LONG BEACH MEMORIAL MEDICAL CENTER EXPANSION  
VOLUME III, ENVIRONMENTAL IMPACT REPORT  
SCH NO. 2004081142

**SECTION 12.0**  
**CLARIFICATIONS AND REVISIONS TO THE**  
**DRAFT ENVIRONMENTAL IMPACT REPORT**

Section 12.0 consists of clarifications and revisions to the Draft Environmental Impact Report (EIR), which have resulted from responses to comments received from agencies and the public. All clarifications and revisions to the Draft EIR were made to increase the understanding of the EIR. The Draft EIR was released for a 45-day public review period between January 25 and March 10, 2005, and the City of Long Beach received 19 letters of comment on the Draft EIR.

**FIGURE R2.1-2**  
Long Beach Memorial Medical Center Location

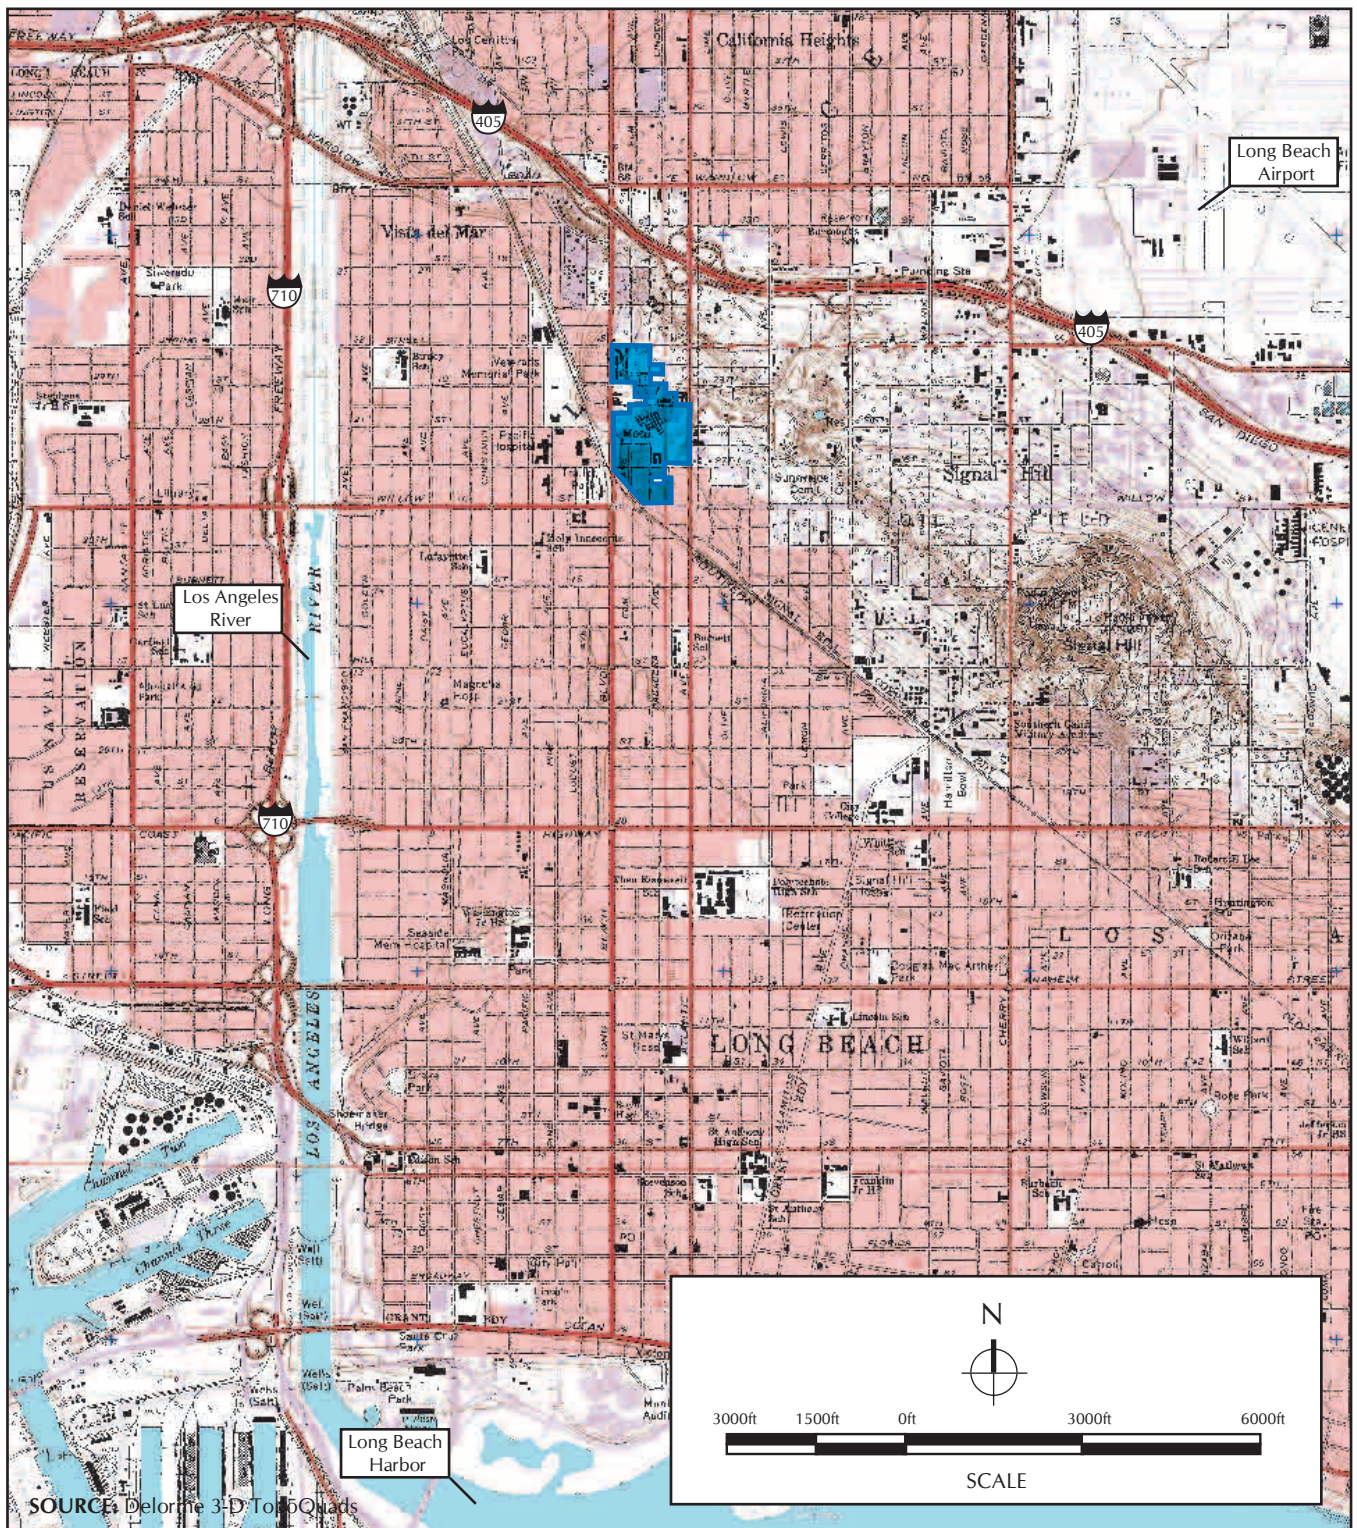
Page 2-1 The northeastern boundary of the Long Beach Memorial Medical Center campus (Campus) was revised in Figure 2.1-2 and replaced by Figure R2.1-2.

In the first sentence of the second paragraph under this heading, please replace the reference to (Figure 2.1-2, *Long Beach Memorial Medical Center Location*) with the following:

(Figure R2.1-2, *Long Beach Memorial Medical Center Location*)

**FIGURE R2.1-3**  
Topographic Map

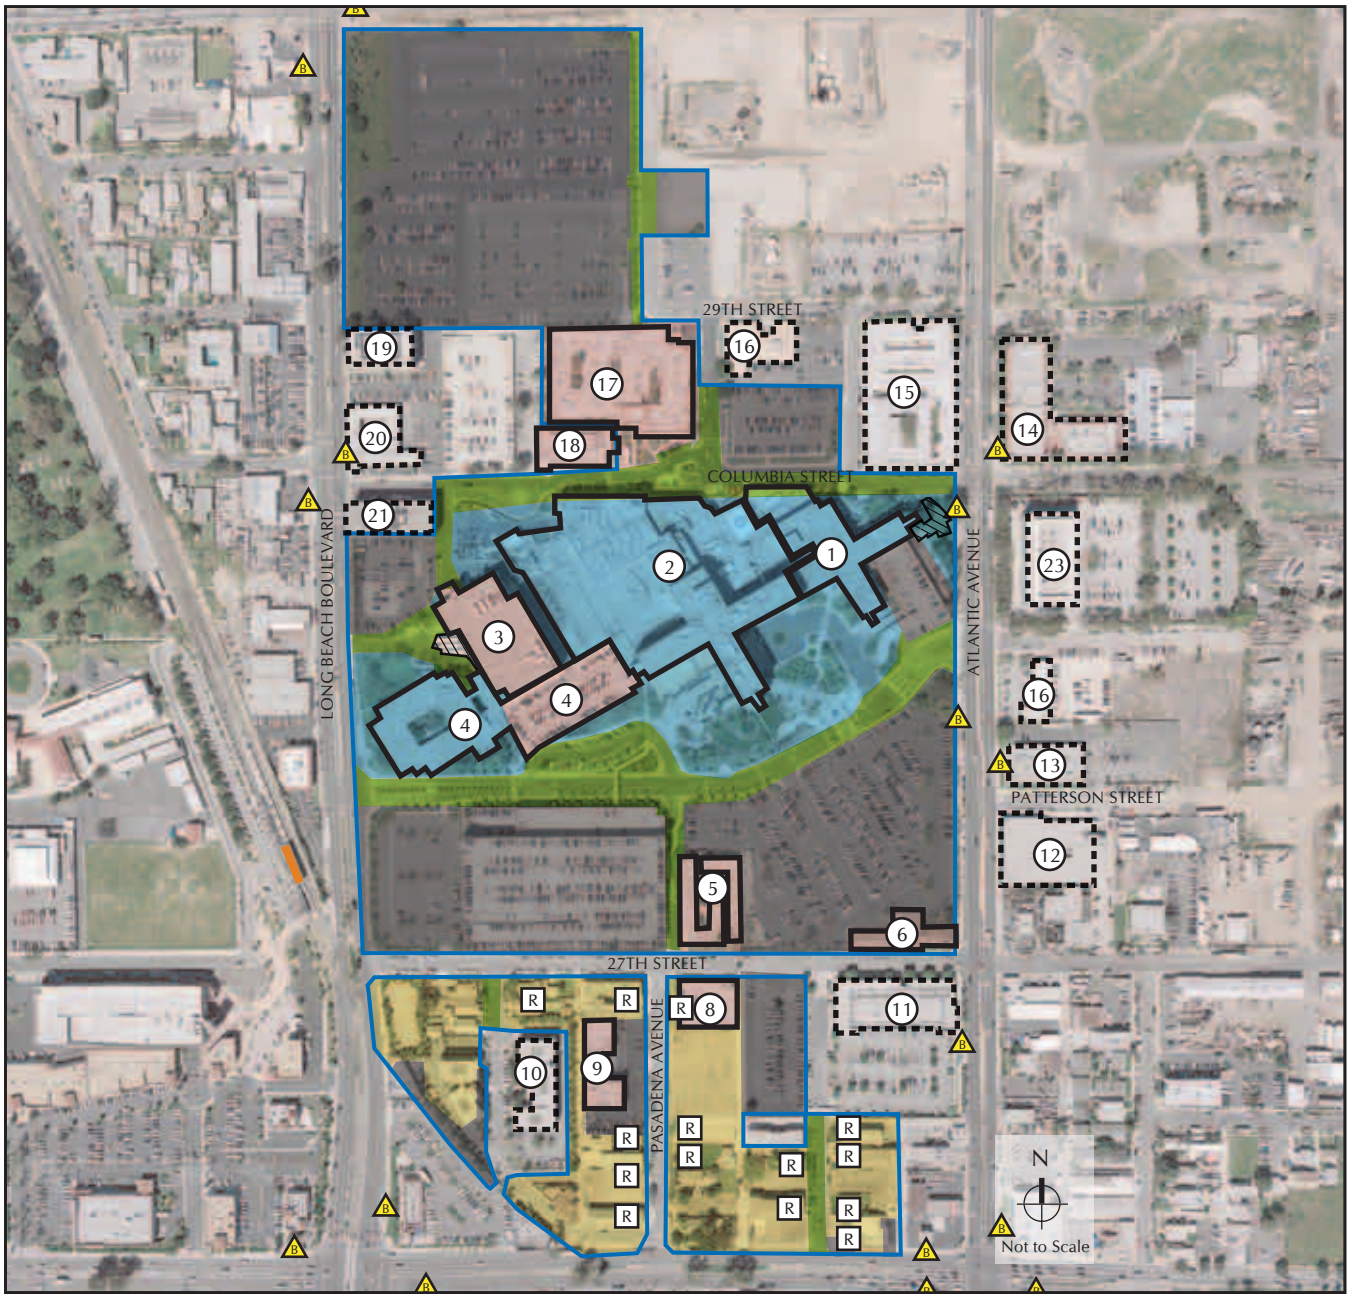
Page 2-1 The northeastern boundary of the Campus was revised in Figure 2.1-3 and replaced by Figure R2.1-3.

In the first sentence of the third paragraph under this heading, please replace the reference to (Figure 2.1-3, *Topographic Map*) with the following:

(Figure R2.1-3, *Topographic Map*)

**FIGURE R2.4-1**  
Proposed Master Plan of Land Uses

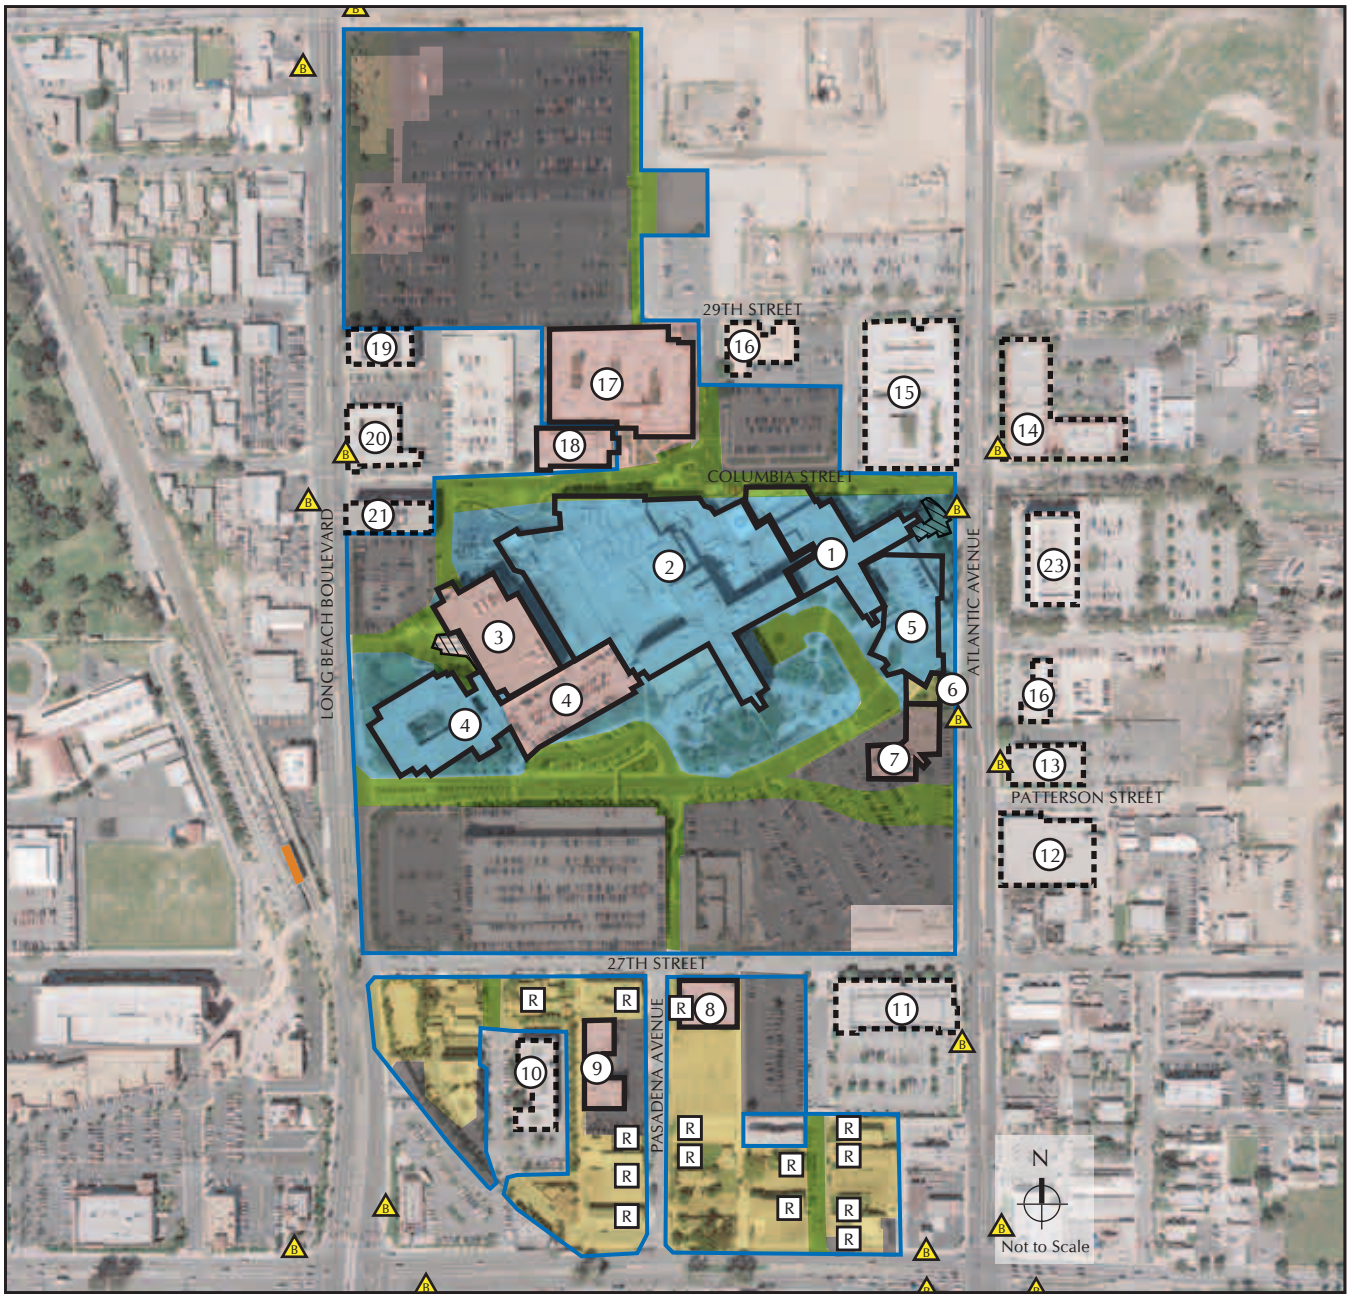
Page 2-6 The northeastern boundary of the Campus, the proposed location of the central plant building, and the conceptual footprint for the Todd Cancer Institute were revised in Figure 2.4-1 and replaced by Figure R2.4-1.

In the first sentence of the first paragraph under this heading, please replace the reference to (Figure 2.4-1, *Proposed Master Plan of Land Uses*) with the following:

(Figure R2.4-1, *Proposed Master Plan of Land Uses*)

FIGURE R2.4.1-1  
Landscape Plan

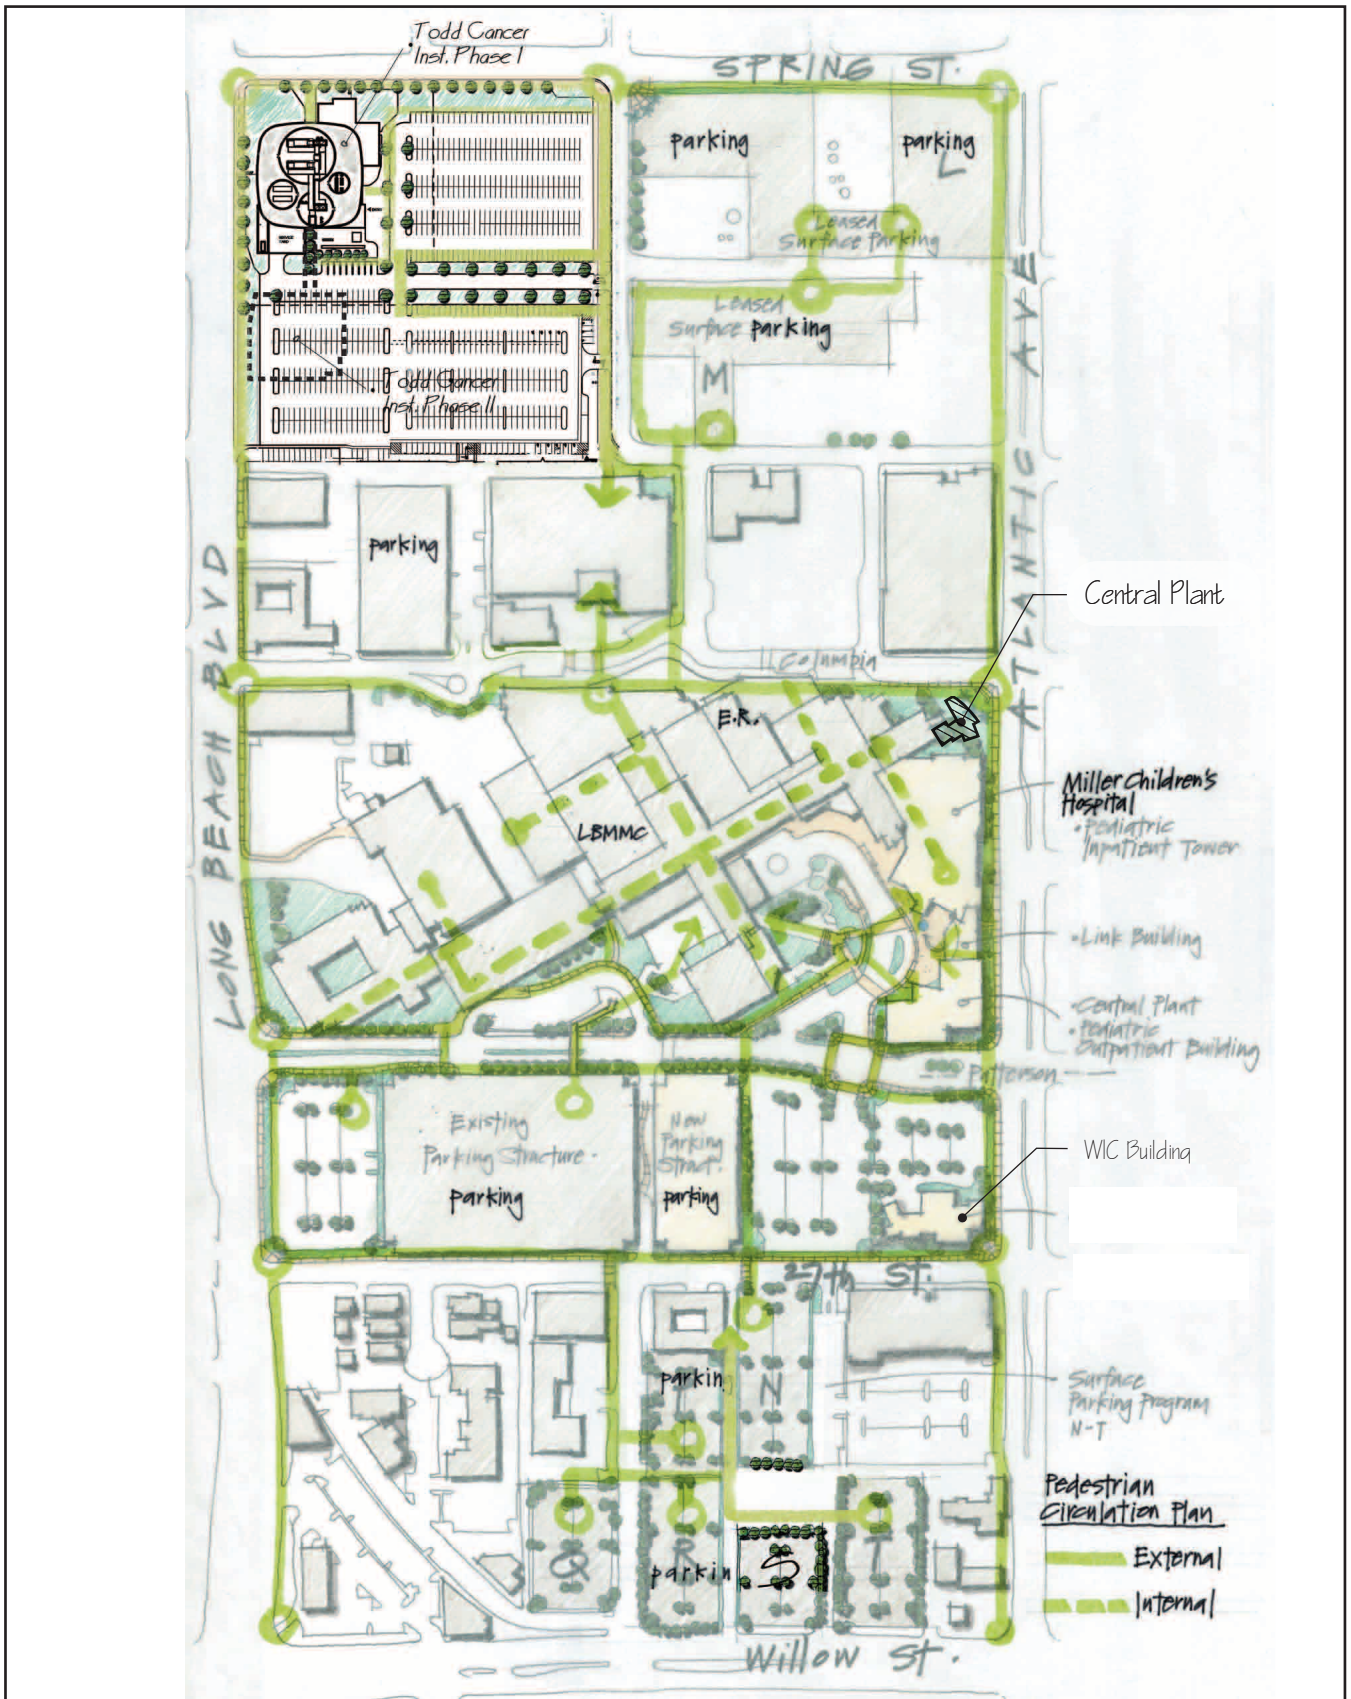
Page 2-8 The northeastern boundary of the Campus, the proposed location of the central plant building, the conceptual footprint for the Todd Cancer Institute, and the conceptual footprint of the proposed parking structure were revised in Figure 2.4.1-1 and replaced by Figure R2.4.1-1. Additional detail from the Master Plan, regarding the types of landscape treatments to be applied to the project elements, is also provided in Figure R2.4.1-1.

In the last sentence of the second paragraph under this heading, please replace the reference to (Figure 2.4.1-1, *Landscape Plan*) with the following:

(Figure R2.4.1-1, *Landscape Plan*)

**FIGURE R2.4.2-1**  
 Todd Cancer Institute Conceptual Site Plan

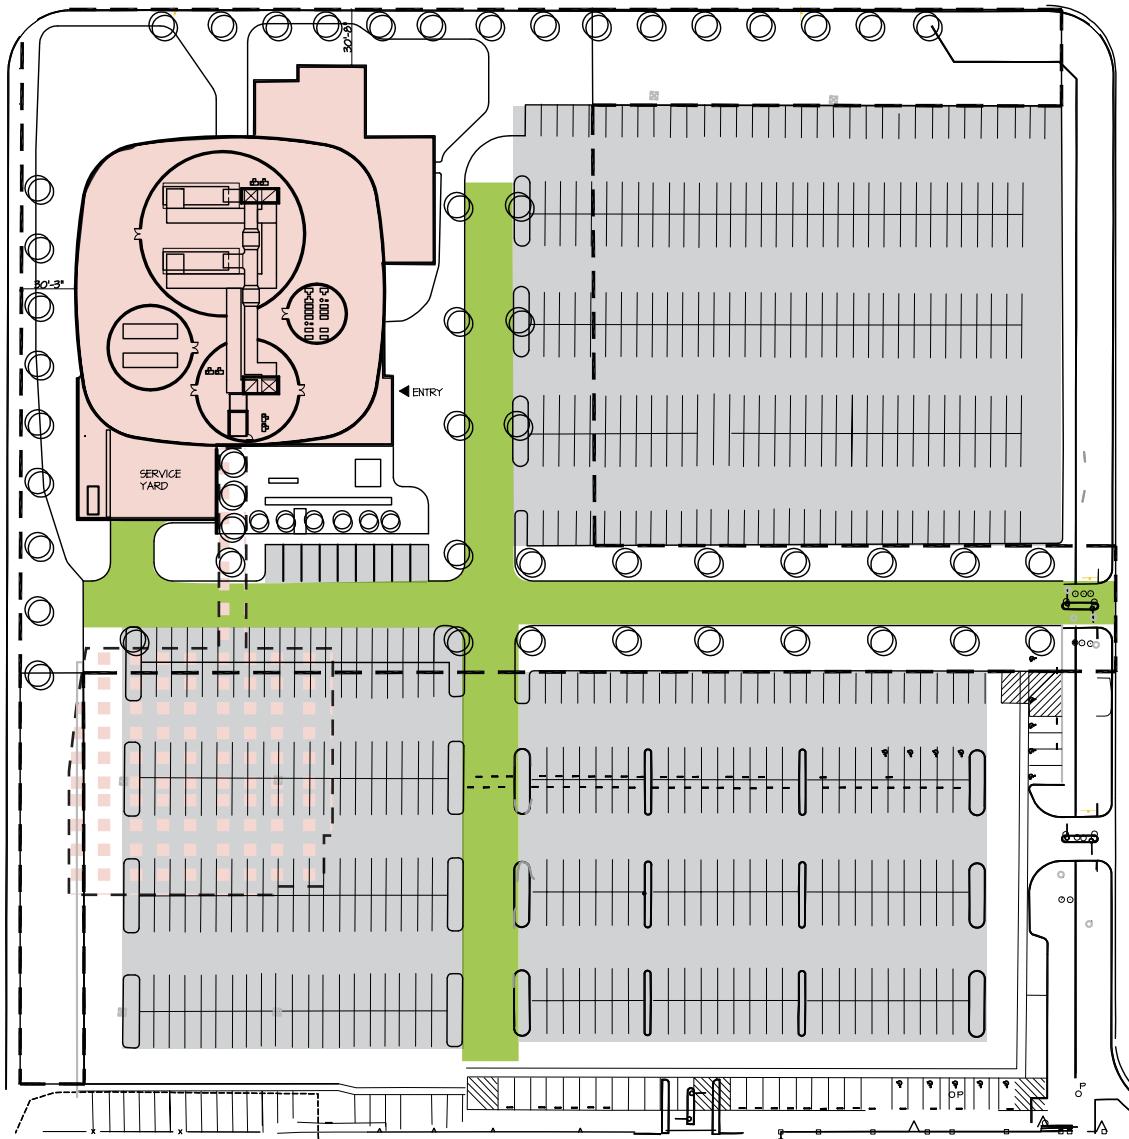
Page 2-9 The conceptual footprint for the Todd Cancer Institute was revised in Figure 2.4.2-1 and replaced by Figure R2.4.2-1.

In the first sentence of the first paragraph under this heading, please replace the reference to (Figure 2.4.2-1, *Todd Cancer Institute Conceptual Site Plan*) with the following:

(Figure R2.4.2-1, *Todd Cancer Institute Conceptual Site Plan*)

**FIGURE R2.4.2-2**  
Todd Cancer Institute Conceptual Drawing

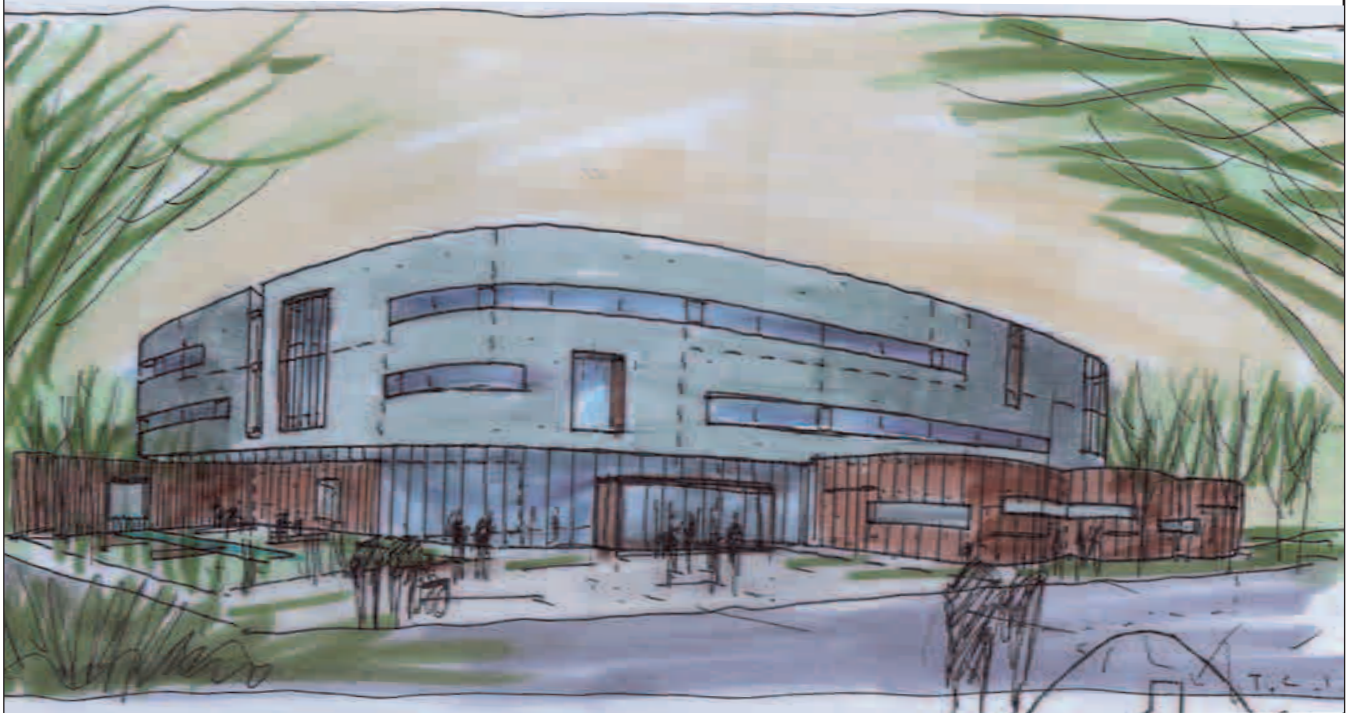
Page 2-9 The conceptual north and south elevations and west and east elevations for the Todd Cancer Institute depicted in Figure 2.4.2-2A and Figure 2.4.2-2B, respectively, were revised to reflect input received by the Long Beach Memorial Medical Center and replaced by Figure R2.4.2-2.

In the third sentence of the first paragraph under this heading, please replace the reference to Figure 2.4.2-2A, *Todd Cancer Institute North and South Elevations*, and Figure R2.4.2-2B, *Todd Cancer Institute West and East Elevations*, with the following:

(Figure R2.4.2-2, *Todd Cancer Institute Conceptual Drawing*)
